A G E N D A  
DESIGN REVIEW COMMITTEE

## STAFF REPORT AND FINDINGS OF FACT

SUBJECT: Design Review Request (DR13-02) by Patrick McGee for Jim and Lori Wolcott to construct a single-family dwelling at 2735 Mill Pond Lane

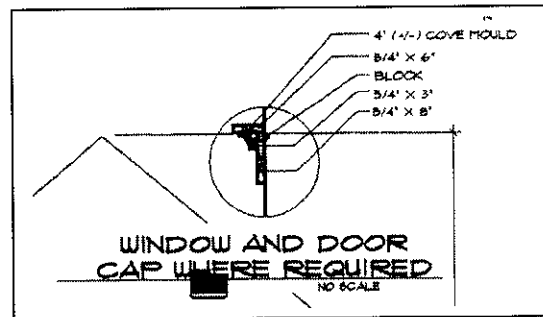
Window and door exterior casings proposed to be 5.5" x 4/4" or larger with lower sill and shall protrude beyond the plane of the siding.

1. Windows and casings shall be installed so that the windows do not protrude beyond the casing; and so that the casing protrudes beyond the plane of the siding. Any windows with grids shall be true divided or shall have external grids.

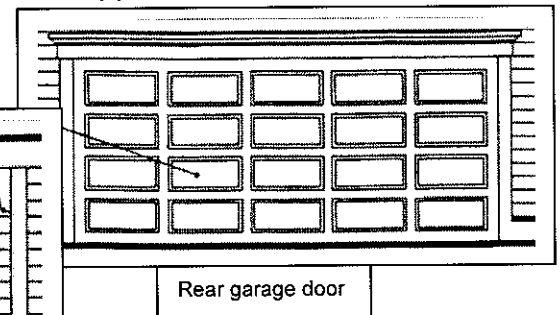
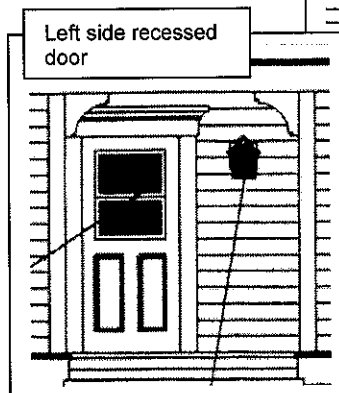
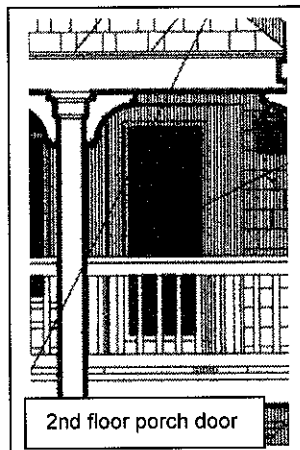
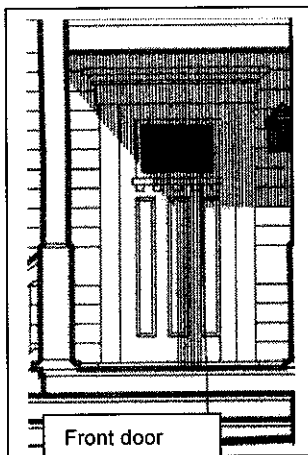
Wood, 3 panel front door with single lite on front; full lite fiberglass French door on front second floor porch; fiberglass panel door with upper lites on left side and transom; wood French doors on balcony; multi-lite panel door on right side. Garage door will be vinyl clad, panel, overhead door, possibly with upper lites, however the diagram does not show the version with upper lites.

2879 Mill Pond Lane  
DR05-14, AEP07-09, AEP07-10, AEP08-11, AEP09-13, AEP12-18, AEP13-01  
7-12-13

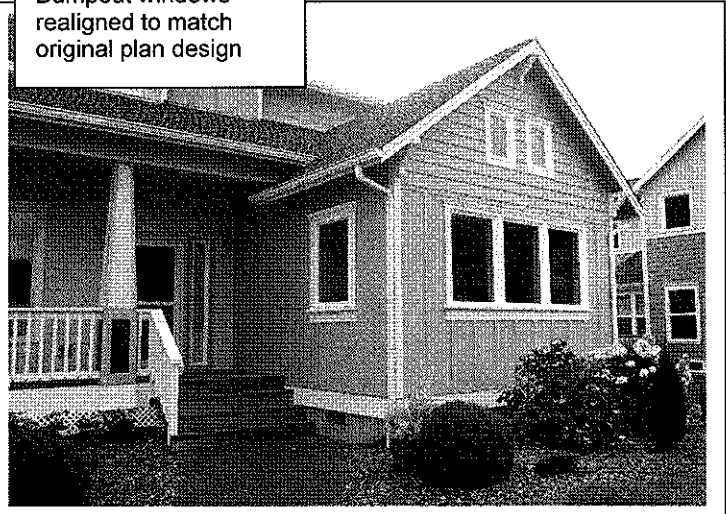
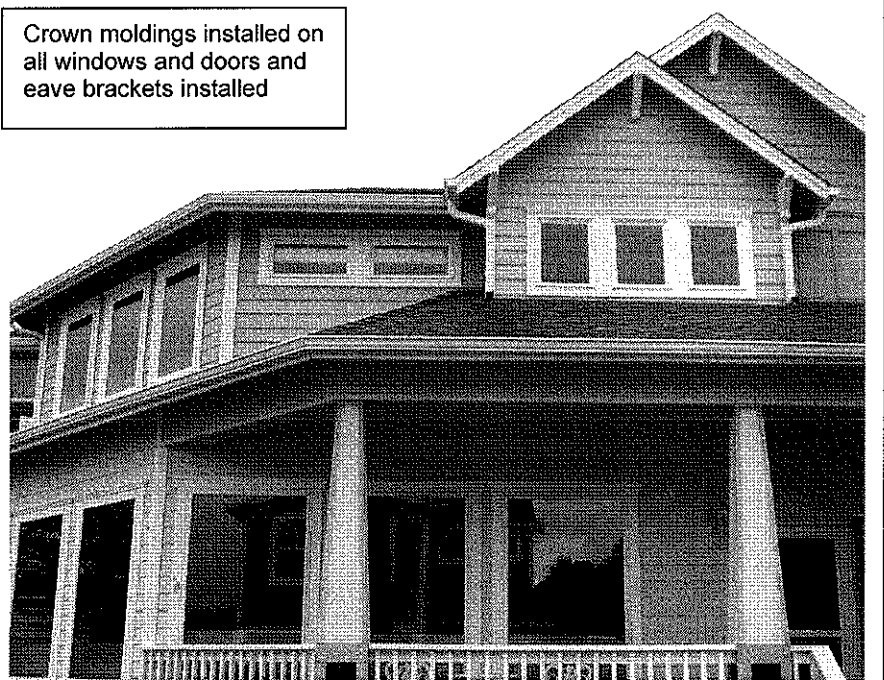
Bumpout windows  
realigned to match  
original plan design

Crown moldings installed on  
all windows and doors and  
eave brackets installed

All conditions met and project is  
complete.
